Docket Item # 3
BAR CASE # 2012-0399

BAR Meeting
April 17, 2013

ISSUE: Alterations (Window Replacement)
APPLICANT: Aloysius and Colleen Boyle by Yetta Rushford
LOCATION: 1103 Powhatan Street
ZONE: RB / Residential

Figure 1: Front Elevation

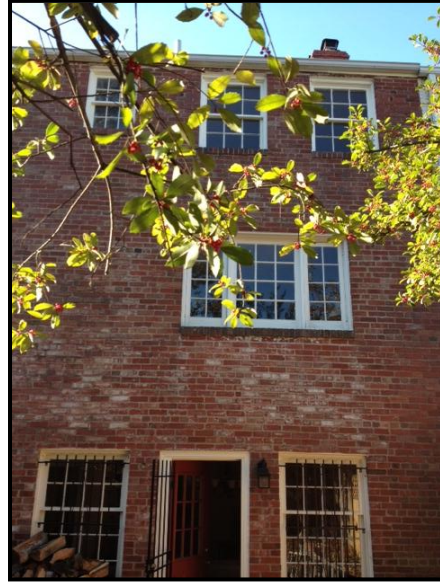
The applicant is requesting a Certificate of Appropriateness to replace the existing single-glazed wood windows with Anderson, Fibrex, simulated-divided light, double-glazed, insert replacement windows to match the existing windows light and operation configurations. (Only the front elevation and the third floor of the rear elevation are visible from a public ROW.)

Additionally, during a site visit for the current application, Staff observed that the multi-light window on the first floor of the front elevation has been replaced with an inappropriate vinyl window with muntins that are sandwiched between the glass. As per the Board's adopted *Window Policy*, vinyl or vinyl clad windows and windows with muntins sandwiched between the glass are not considered appropriate or compatible by the Board for use on any building. Staff recommends that the Board require that a new, Fibrex, SDL multi-light picture window or another BAR approved window be installed as part of the present application and this work will be completed as a condition of this approval. If the picture window is not corrected by July 1, 2013, then the owner will not be in compliance with their Certificate of Appropriateness and fines may be assessed, as defined in the zoning ordinance.

1. That the final SDL Fibrex insert window specifications be approved by BAR staff in the field, to insure that they are made as large as practical, and that the windows still meet all other applicable requirements of the Board's *Window Policy* and the Alexandria Replacement Window Performance Specifications #2-9.
2. That a new Fibrex, SDL multi-light picture window, or another window approved by the BAR, will replace the existing vinyl sandwich muntin window installed on the first floor of the front elevation. If the picture window is not corrected by July 1, 2013, then the owner will not be in compliance with their Certificate of Appropriateness and fines may be assessed, as defined in the zoning ordinance.
3. That the new windows will match the existing window operation and configuration (ie. Double-Hung Sash, Casement, Fixed Sash, etc. will be replaced in-kind)
